Access Compliance Report

Public Rights-of-Way

(Curb Ramps)

Intersection ID: 3107	Main Street: GROSBEAK_LN	Cross Street: MOURNING_DOVE_LN	Location: E
ADA ID: DBCAAA289268	Ramp Type: Perp	Initial Pass/Fail: Fail	Overall Compliance: No
Severity Score: 35			
Codes/Mitigation Info/Possible Solution		Field Measurements/Component Compliance

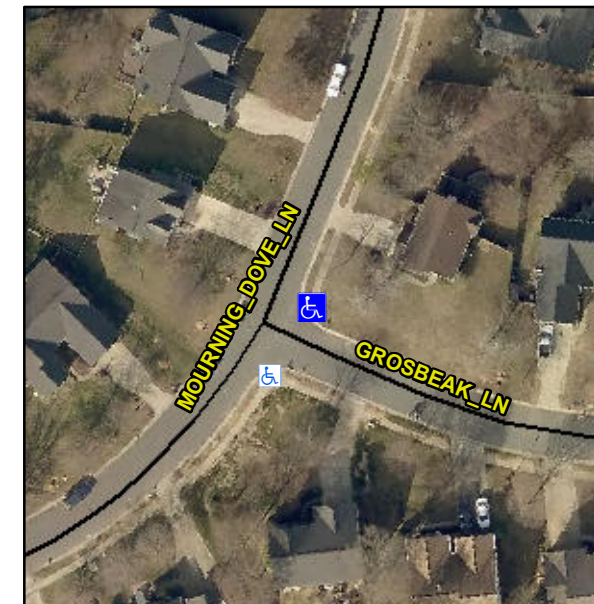
R304.5.1, R304.2.2, R304.5.3

Compliance	Description	Data	Compliance	Description	Data
N/A	Ramp Length (in)	98.0	No	Ramp Slope (%)	13.1
No	Ramp Width (in)	46.5	No	Ramp XSlope (%)	4.3
N/A	Flare Type LT	N/A	N/A	Flare Type RT	N/A
N/A	Flare Slope LT (%)	N/A	N/A	Flare Slope RT (%)	N/A
N/A	Flare Traversable LT?	N/A	N/A	Flare Traversable RT?	N/A
N/A	Landing Length (in)	N/A	N/A	DWS Provided?	N/A
N/A	Landing Width (in)	N/A	N/A	DWS Contrast?	N/A
N/A	Landing Slope (%)	N/A	N/A	DWS Length (in)	N/A
N/A	Landing X Slope (%)	N/A	N/A	DWS Full Width?	N/A
N/A	Landing Curb? (Y/N)	N/A	N/A	DWS Offset (in)	N/A
N/A	Shared Landing?	N/A			
N/A	Gutter Ponding?	N/A	N/A	Gutter Slope (%)	N/A
N/A	Gutter Lip Ht (in)	N/A	N/A	Gutter X Slope (%)	N/A
N/A	Painted X Walk1?	No	N/A	Painted X Walk2?	N/A
	X Walk 1 Direction	To SW		X Walk 2 Direction	N/A
N/A	X Walk 1 Width (in)	N/A	N/A	X Walk 2 Width (in)	N/A
	X Walk 1 Slope (%)	1.0		X Walk 2 Slope (%)	N/A
	X Walk 1 X Slope (%)	1.8		X Walk 2 X Slope (%)	N/A

Remove & Replace Entire Ramp.
